CITY OF YORK COUNCIL	Stage 1/2 Road Safety Audit Report
---	---

Safety Audit Ref	25/016	Version no.	01
Scheme Title:	Outgang Lane to G&T site – Road Safety Improvements		
Site Location details:	Outgang Lane, Osbaldwick		
Recharge code:	CJ045		
Date:	26/08/2026		
Prepared by:	CYC – Transport Projects		
On Behalf of:	CYC - Transport Projects and Housing

Plan 1

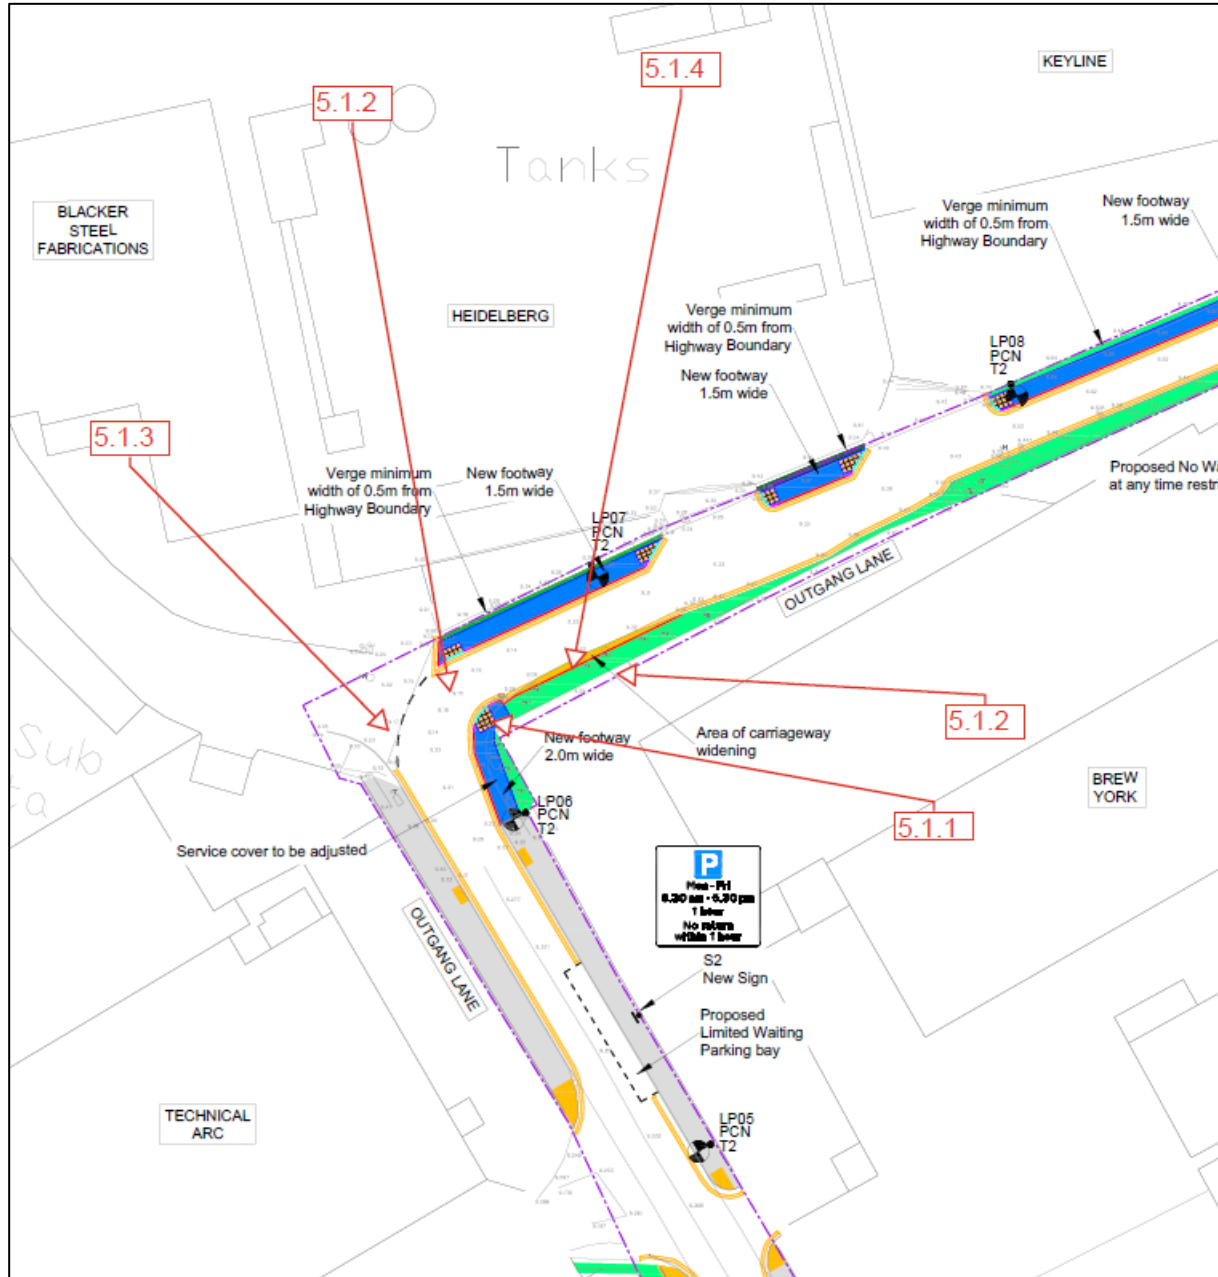
PROBLEM – Ref: 5.1.1	
Location:	Bend
Summary:	Risk of vehicles mounting footway at crossing point
The pinch point created by the new footway could lead to longer vehicles mounting the southern footway at the new crossing point. This could introduce a pedestrian strike risk.	
Recommendation	
The kerb line should be reviewed and if required changed to mitigate the risk at the crossing. Vehicle swept path analysis of the route indicating how vehicles will negotiate the new alignment should be carried out and provided as part of the audit response.	
Designer's Response	
Overseeing Organisation Response	
Agreed Action

PROBLEM – Ref: 5.1.2	
Location:	Bend
Summary:	Head on collision risk
The tighter bend created by the new footway forces left turning vehicles across to the offside to negotiate the bend. This introduces a risk of head on collisions.	
This issue is exacerbated by the hoarding on the fence at Brew York which removes visibility between vehicles at the critical point (see photos).

PROBLEM – Ref: 5.1.3	
Location:	Access to Blacker Steel Fabrications
Summary:	Speed of entry in conflict with vehicles from the right
The current access to Blacker Steel Fabrications doesn't slow traffic as they enter or promote vehicles to slow as they approach the bend. This is in an area of direct conflict with vehicles negotiating the left-hand bend as they approach from the east. This could result in serious collisions or loss of control if fast approaching vehicles try to brake heavily and steer on the dusty access road.

PROBLEM – Ref: 5.1.4	
Location:	Verge near the bend
Summary:	Risk of vehicles striking rocks.
The rocks appear to have been placed in the verge to reduce overrun. Retaining these in the existing verge and maintaining the minimum 450mm offset from the kerb or edge of carriageway may be difficult due to their size. This could create a risk of turning vehicles striking the rocks and potentially losing control. The rocks are not a properly designed vehicle restraint system and so bring with them inherent risks.	
Recommendation	
The rocks should be removed off site and replaced with a suitable vehicle restraint system similar to what is in place alongside the water feature on the northern boundary.

PROBLEM – Ref: 5.1.5	
Location:	Carriageway at Waggy Dog
Summary:	Risk of vehicles mounting the footway
The existing layout provides verges on both sides of the carriageway which provides a suitable overrun if two vehicles meet on the narrow single lane carriageway. Introduction of a footway will remove one of the verges and could result in vehicles mounting the footway introducing a risk to pedestrians.	
Recommendation	
The introduction of a passing place in the northern verge should be considered to accommodate this movement and reduce the risk of vehicles mounting the footway.	
Designer's Response	
Overseeing Organisation Response	
Agreed Action

PROBLEM – Ref: 5.1.6	
Location:	Verge opposite Waggy Dog
Summary:	Risk of vehicles striking a rock
There is a rock in the verge opposite Waggy Dog (pictured below) which could pose a risk to vehicles mounting the verge if it is overgrown with vegetation.

Plan 2

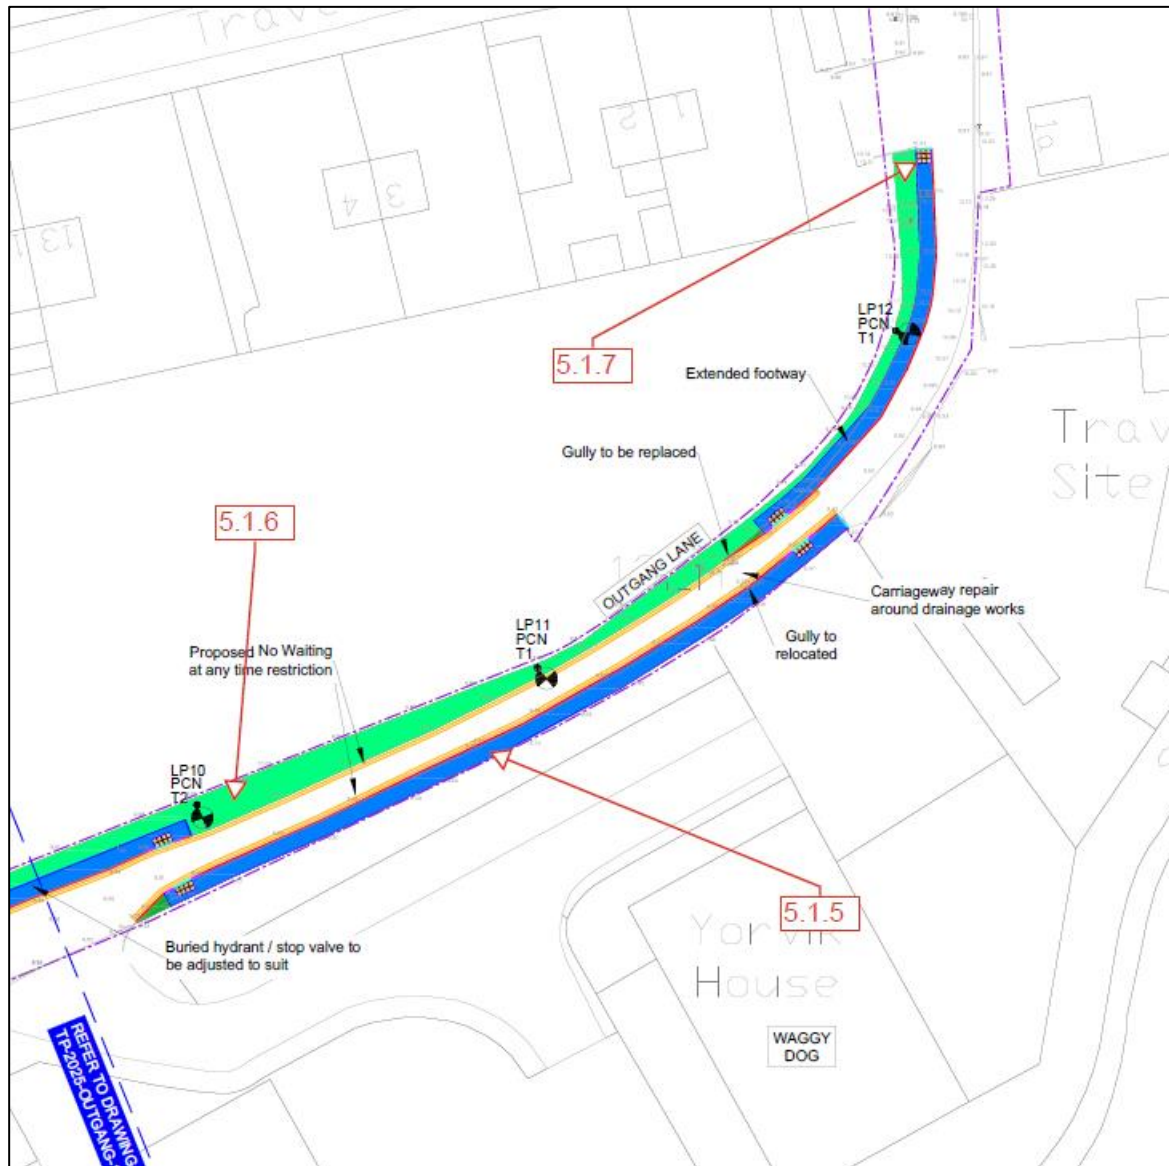
PROBLEM – Ref: 5.1.7

Location: End of new footway

Summary: Incorrect tactile use – confusing

The footway ends with an area of blister tactile paving which is usually used to indicate a crossing. Could result in blind or partially sighted pedestrians entering the carriageway / car park area expecting to find a corresponding area of tactile for the crossing point.

The footway / travellers site interface should be redesigned to remove the blister paving and provide a suitable solution for transferring pedestrians in to the shared use area of the traveller's site.
